**Application Number:** 20/03015/DISCON

**Description:** Details submitted pursuant to discharge condition 4 (hard and soft landscaping details) attached to planning application 18/01469/FUL

**At:** 22 - 24 Stantonbury Centre Purbeck Stantonbury

**For:** Aldi Stores Limited

# 1308-01 Rev E Soft Landscape Proposals (partial screenshot)

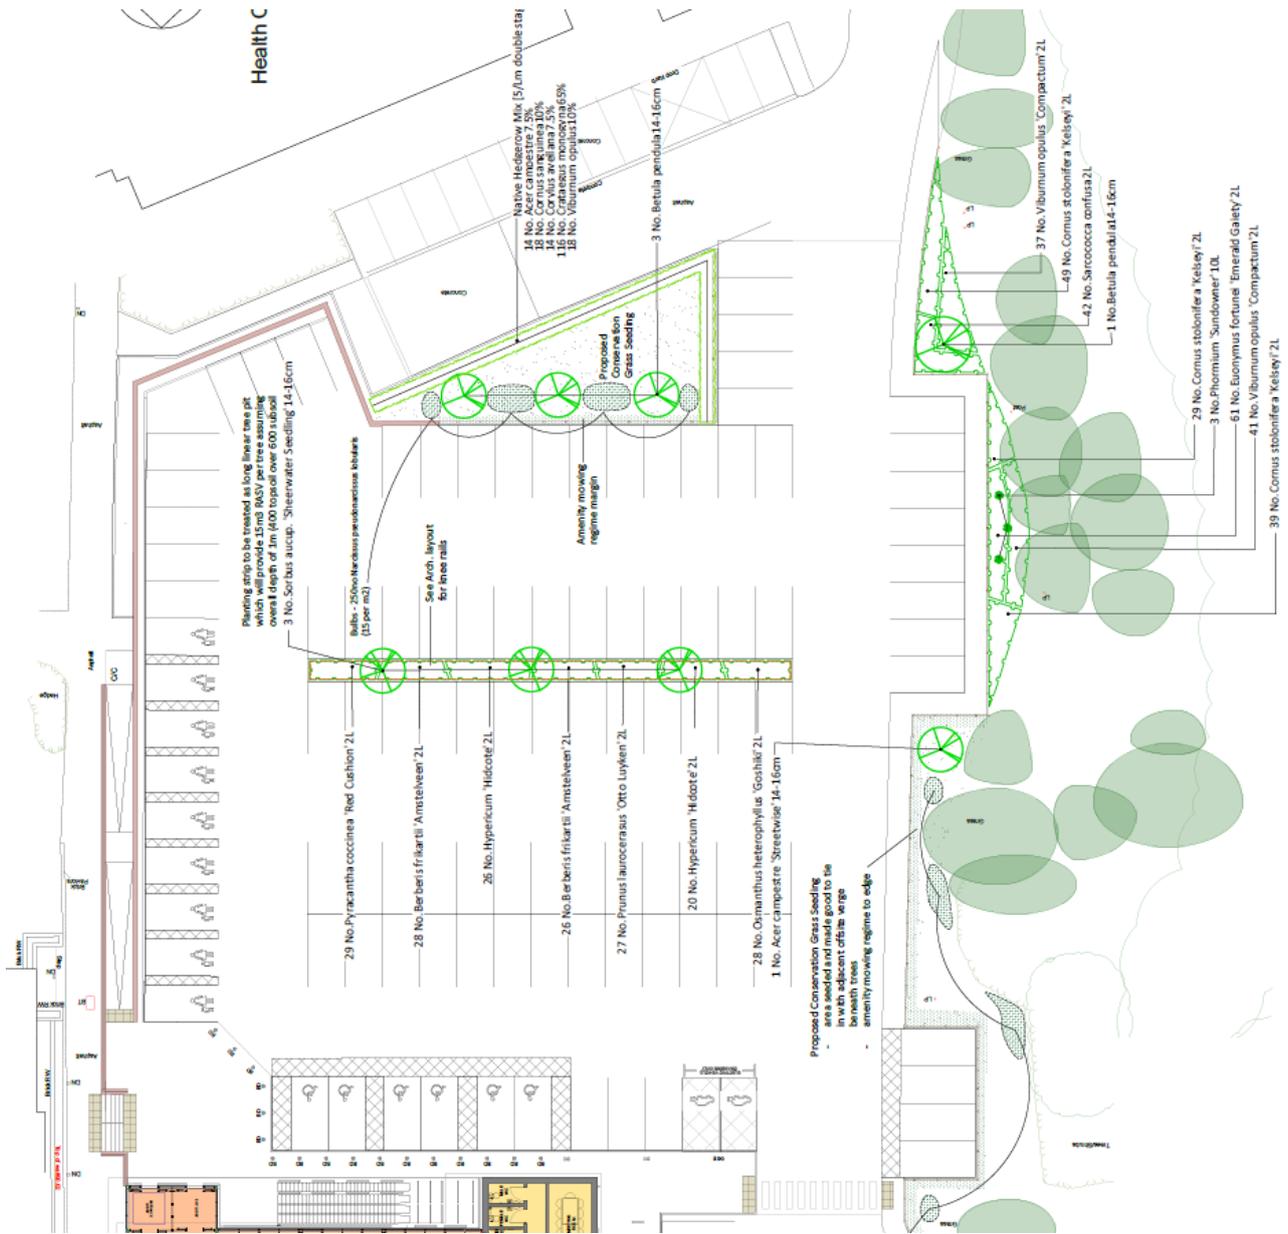
in line with previous discussion by Members. Comments received regarding the layout of proposed planting includes a suggestion of relocation of a tree specimen. This would result in landscaping falling outside the site boundary. Subsequently this would not be a plausible option as it would limit enforceability. In addition, there are no objections in terms of highway safety or access as a result of this tree location.

- 5.4 Queries have been raised relating to the long-term maintenance of the mural in respect of the planting. This issue was not explicitly included as a requirement of the original condition. Nonetheless, it will be necessary for the site operator to maintain all landscape and physical features in their control, as part of general day to day management, and this landscaping would be included. The operator of the site has responded on this point and concurs that maintenance would be part of the general site upkeep and no further reporting is required. Furthermore, the species proposed is observed to be generally low growing.

'No objection to the proposed details subject to the Council's Senior Landscape Architect confirming that the species in front of the mural will not grow to such a height that it will obscure the mural itself.'

'I would say that the plants are the wrong plant for the location due to the lack of maintenance access and should be substituted for robust, low maintenance shrubs that don't grow above the height of the bottom tiles.'

- 5.5 As a result, although there remains an outstanding concern in terms of the height of the planting proposed; in the longer term it is important to consider the submission in its entirety. The details provided have followed guidance provided by Members and meet the requirements of the detailed condition wording in terms of technical compliance. Consequently, the Committee is requested to consider the details as submitted which are considered to provide the requisite details in compliance with the condition.

**140133-1400-P10 Proposed site plan revised 16/12/2020 (cropped to mural location with fence detailing shown)**

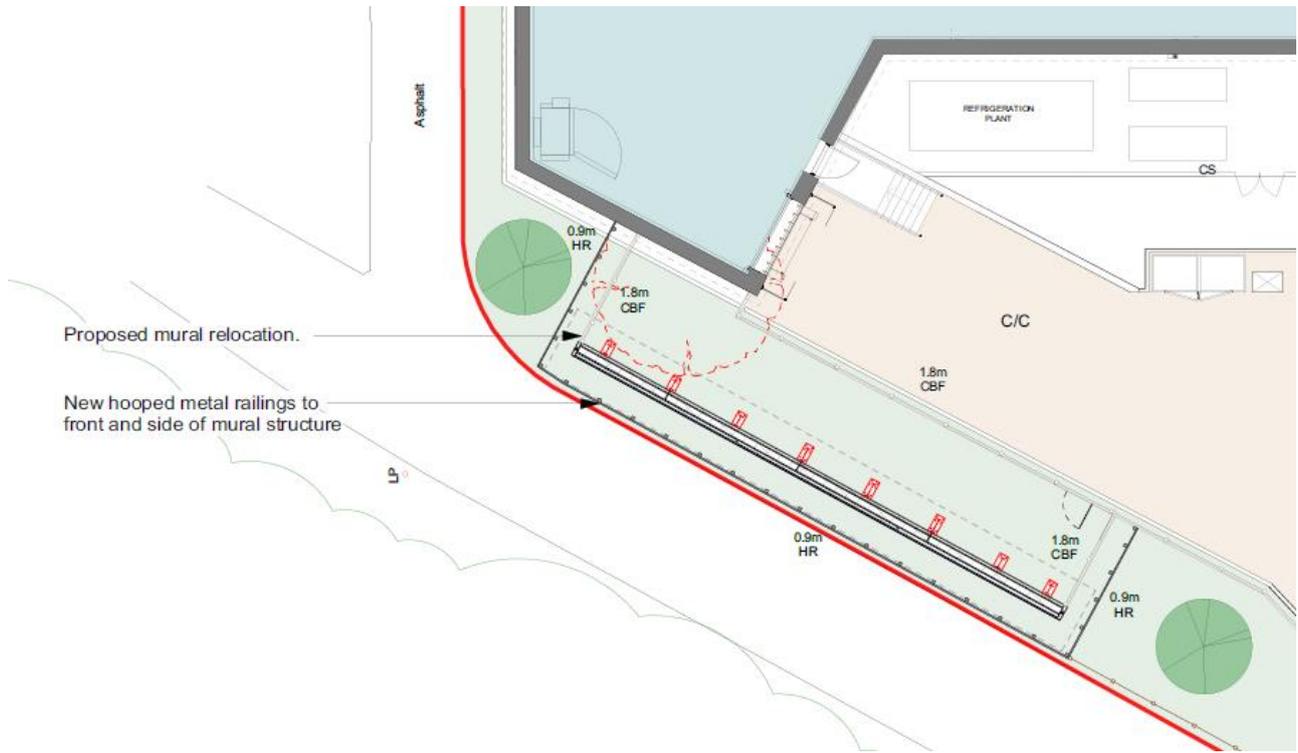
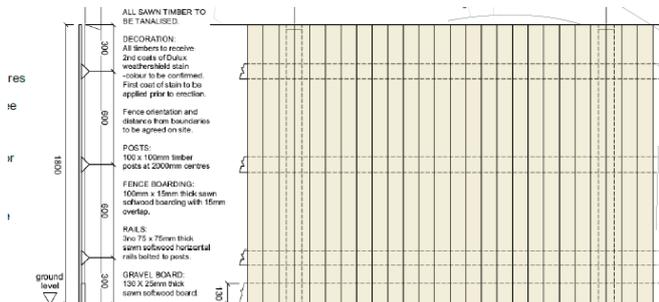
5.3 Due to the re-erection of the mural having been previously approved in a slightly (approximately 1.5 metres) amended position adjacent and closer to the Redway, there is a reduced capacity for defensible planting. As a result, the knee-rail has been upgraded to a section of 1 metre high railings to ensure a greater level of protection
